**DeKalb County Department of Planning & Sustainability**

**STAFF ANALYSIS**

**Case No.:** SLUP-21-1244886 **Agenda #:** D3

**Request:** Special Land Use Permit (SLUP) request to allow for a drive-through restaurant.

SHEET NUMBER:  
**C-2.0**

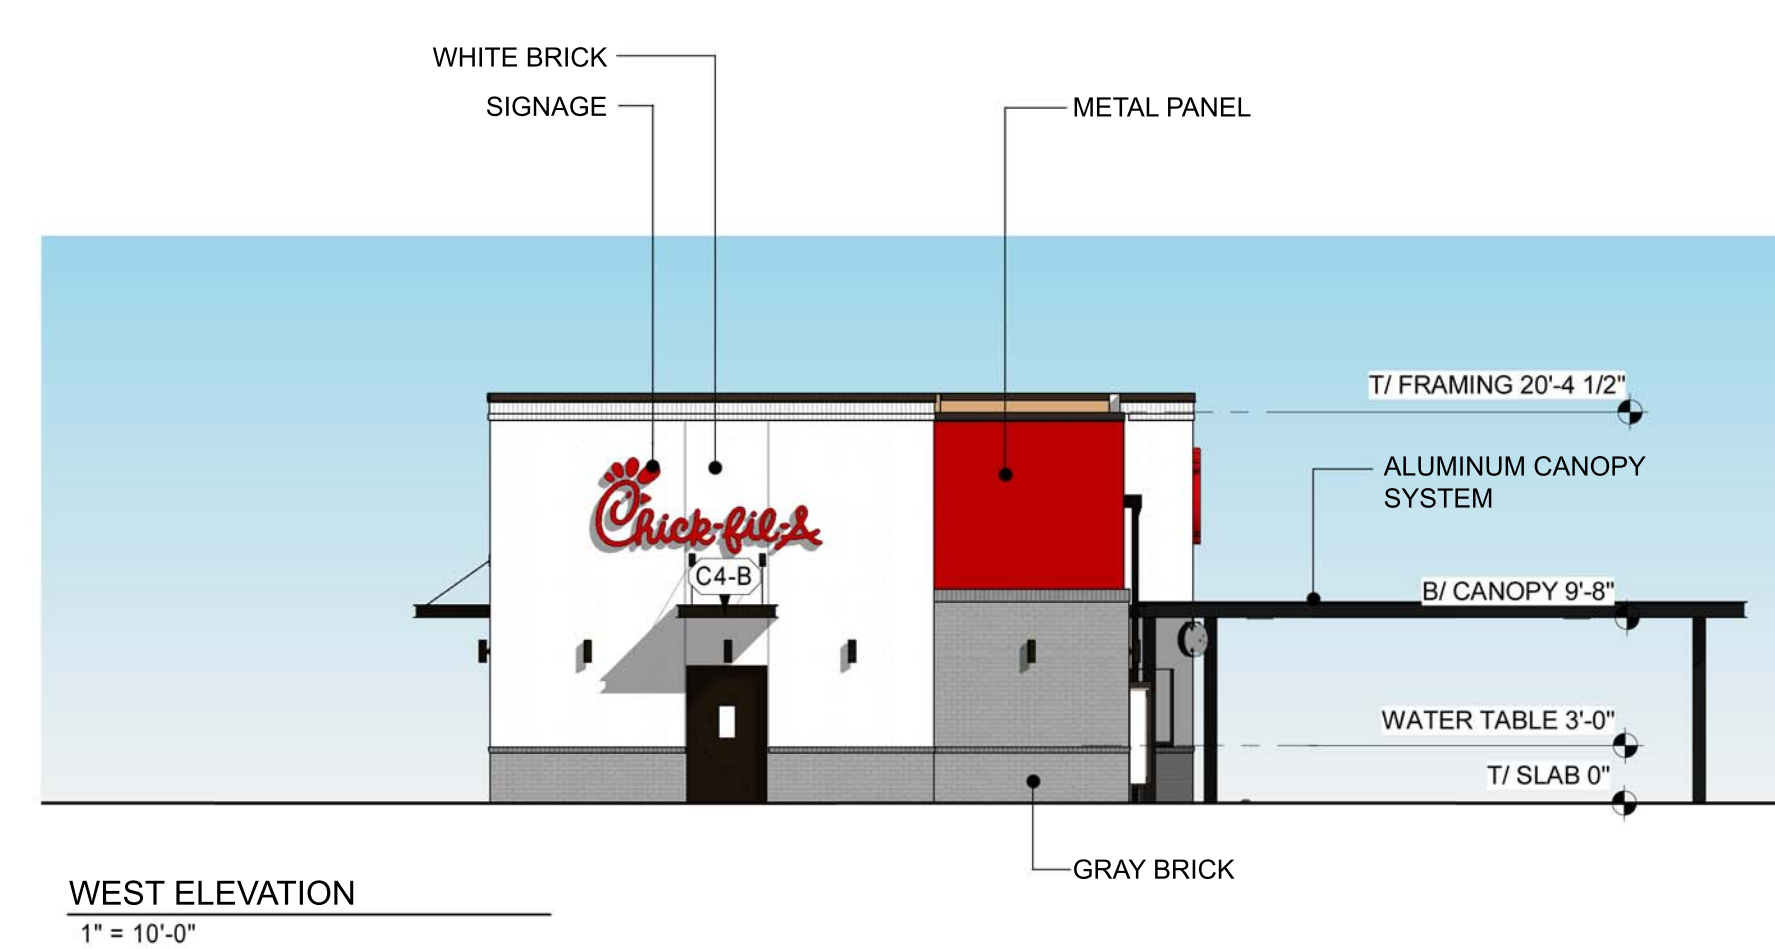
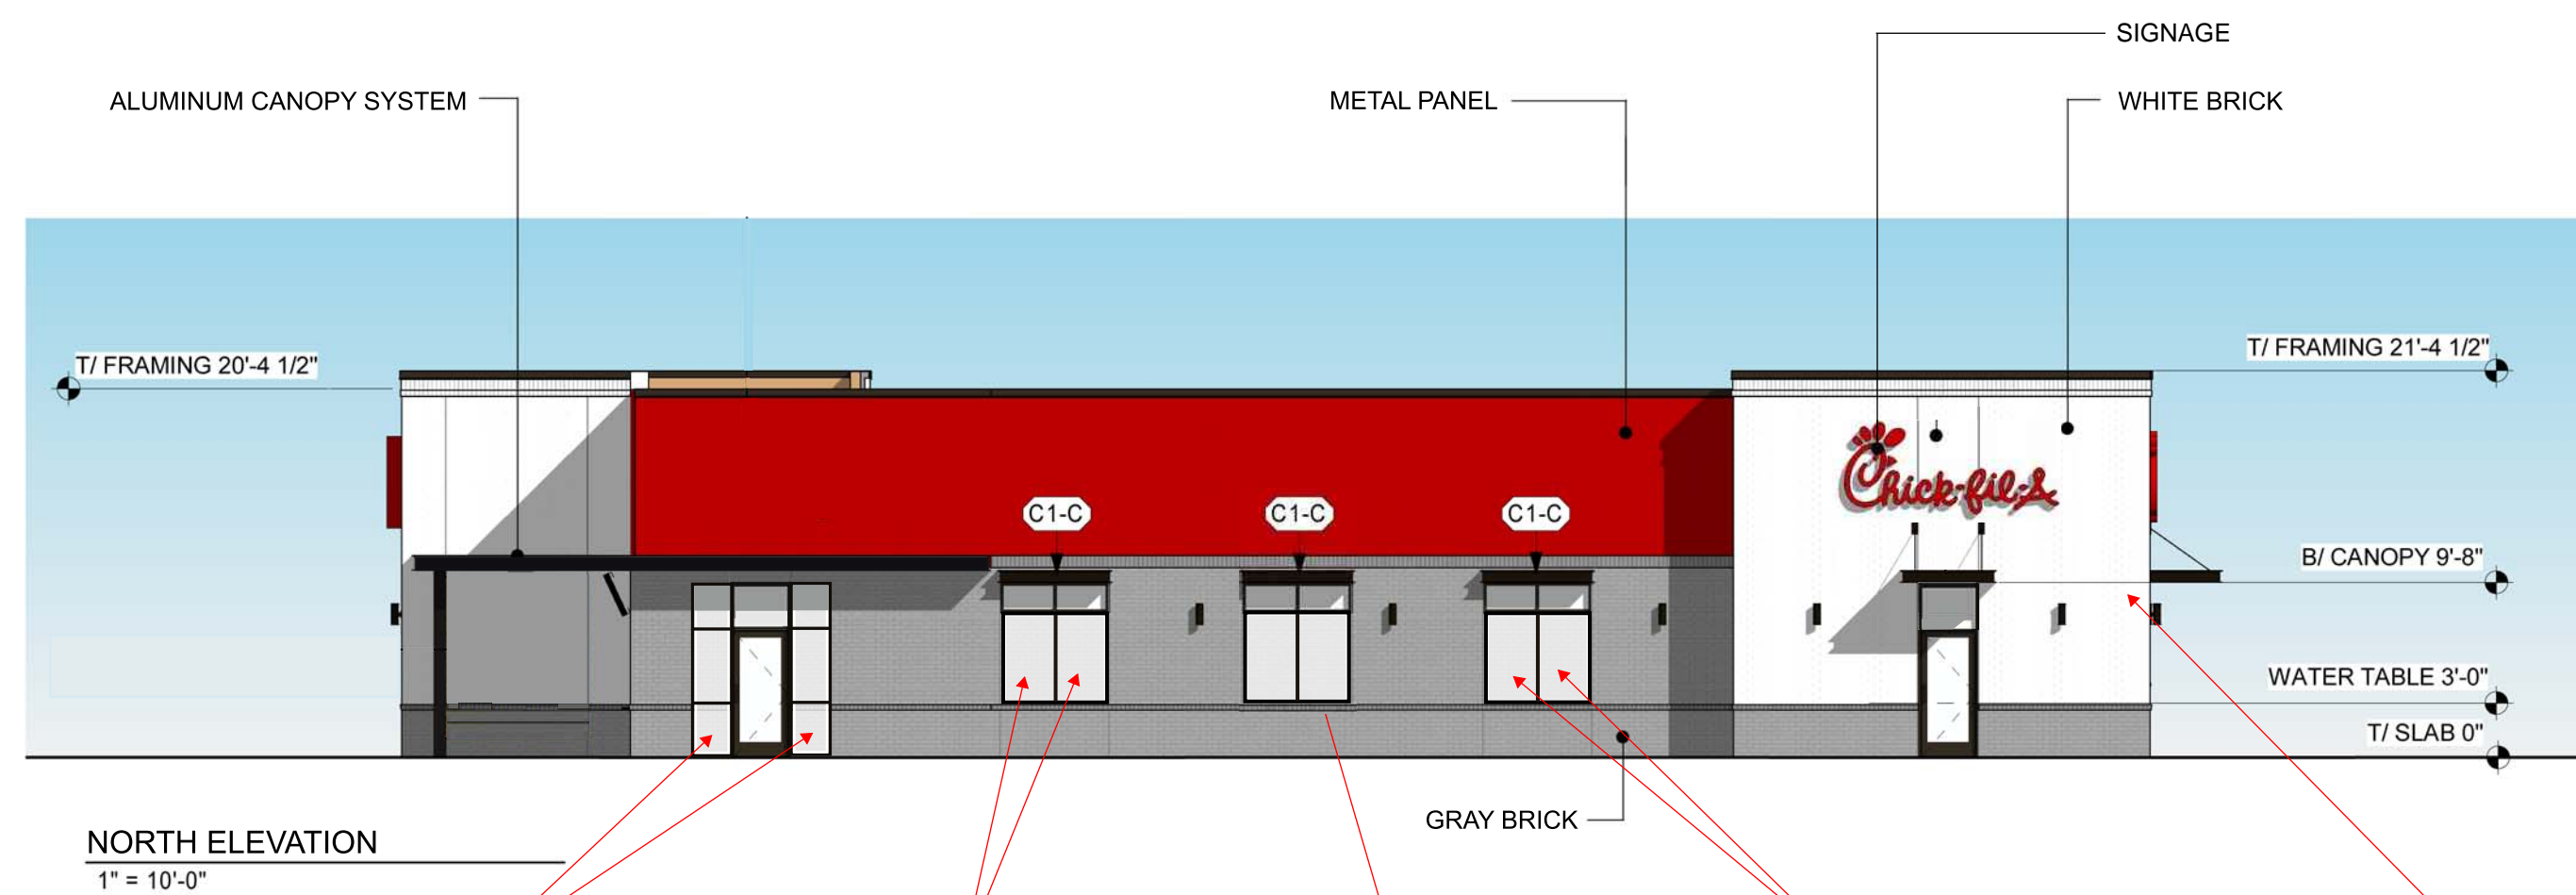
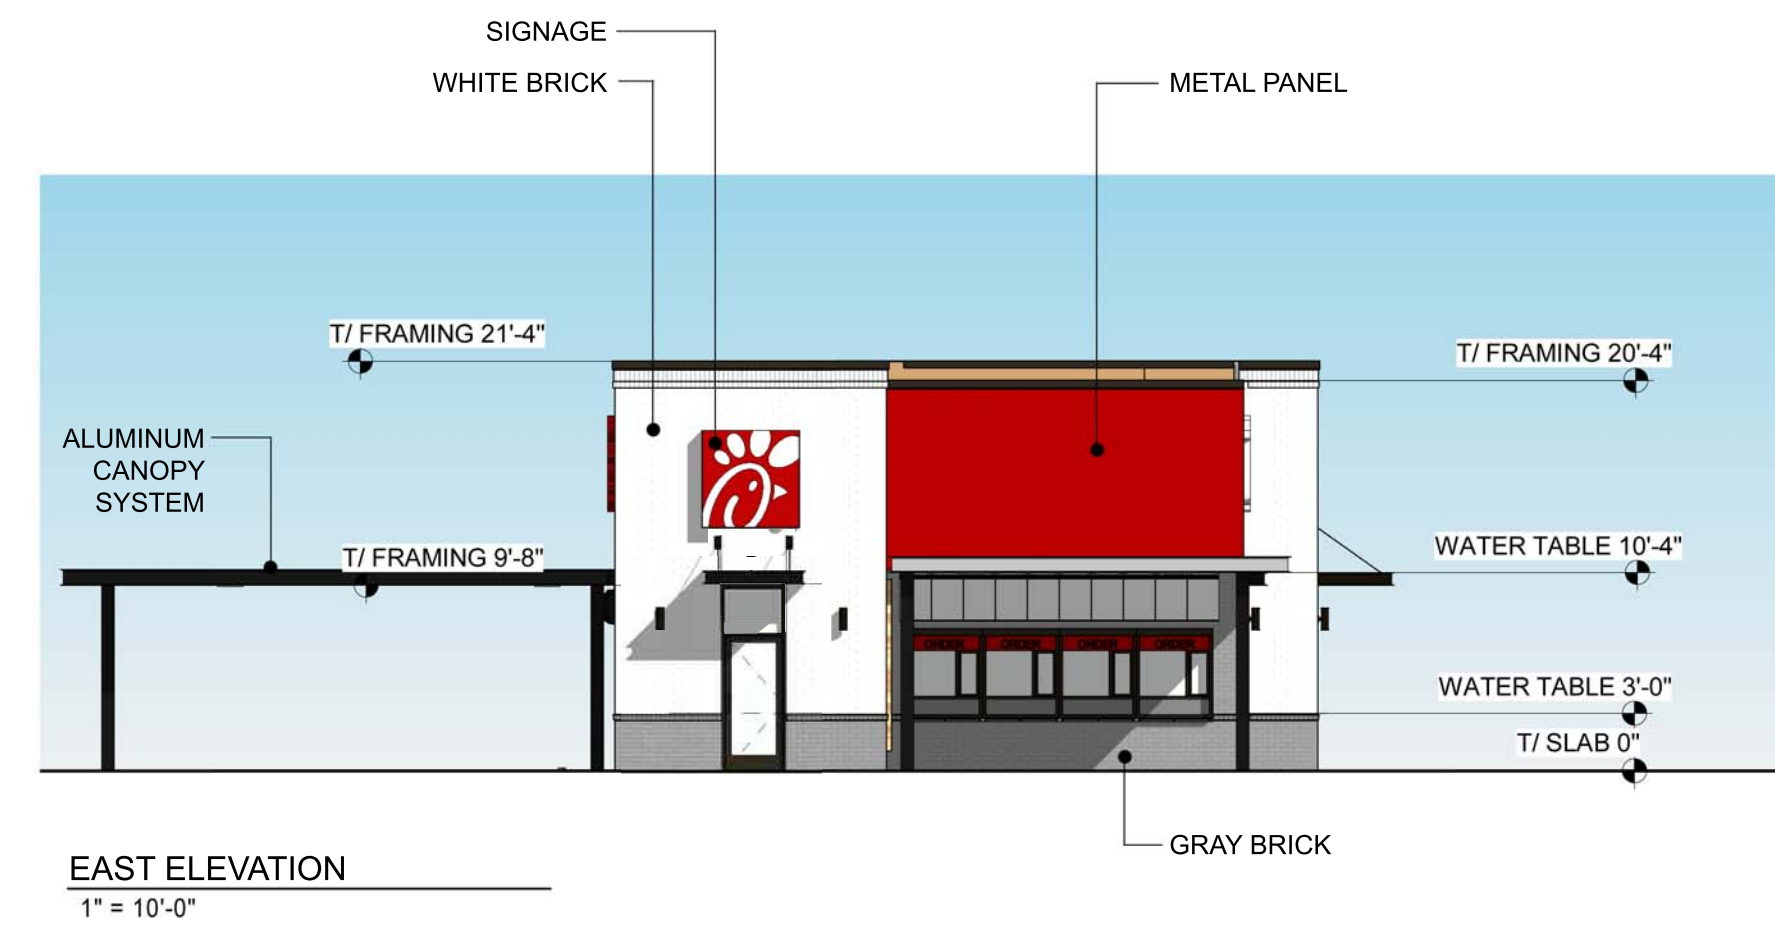
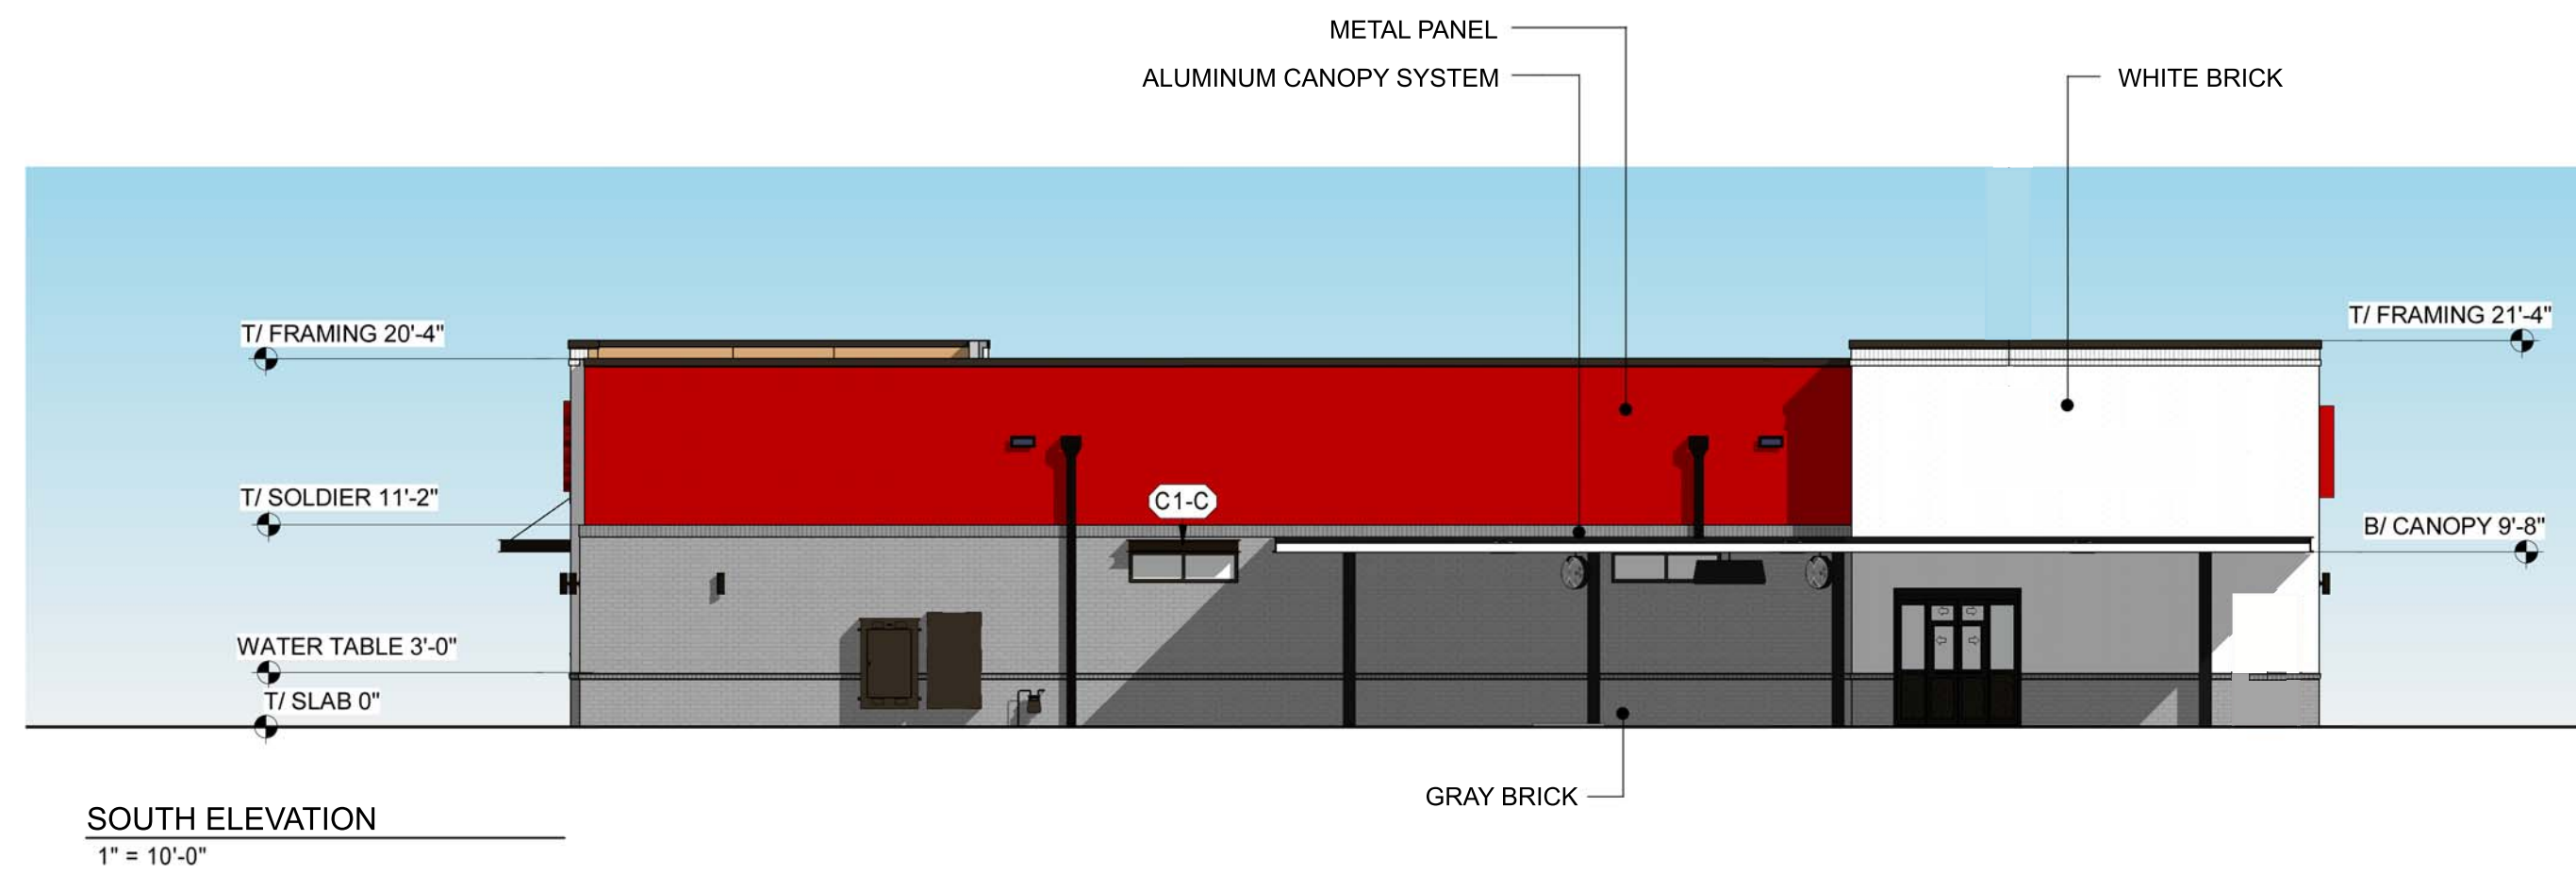
According to the site plan, internal circulation is centered on a "horseshoe" pattern to access three canopied drive-through lanes that narrow to two lanes for food delivery and parking around the perimeter of the site. Assuming the bulk of sales are via drive-through service, the proposed circulation plan may create a few issues: 1. the 2 parking spaces for disabled patrons are away from the building and close to the right in/right out access point at North Druid Hills Road; 2. drive-thru patrons who have received their food will also depart near the handicapped spaces and as patrons enter from North Druid Hills; 3. given the proposed layout, reasonable signage may be necessary to ensure internal circulation flows as intended.

- g. **Stacking spaces shall be provided for any use having a drive-through facility or areas having drop-off and pick-up areas in accordance with the following requirements. Stacking spaces shall be a minimum of ten (10) feet wide and twenty-five (25) feet long. Stacking spaces shall begin at the last service window for the drive-through lane (typically the "pick-up" window). Per the submitted preliminary site plan, the stacking spaces are 11.5' wide and meet the 25' minimum in length.**

- h. **All drive-through facilities with the exception of drive-through restaurants shall provide at least three stacking spaces for each window or drive-through service facility. Per the submitted preliminary site plan, there are 41 car stacking spaces provided.**

- ii. **Drive-through lanes shall be separated by striping or curbing from off-street parking areas. Individual lanes shall be striped, marked, or otherwise distinctly delineated. Based on the submitted preliminary site plan, there appears to be striping and material delineation shown to separate lanes.**
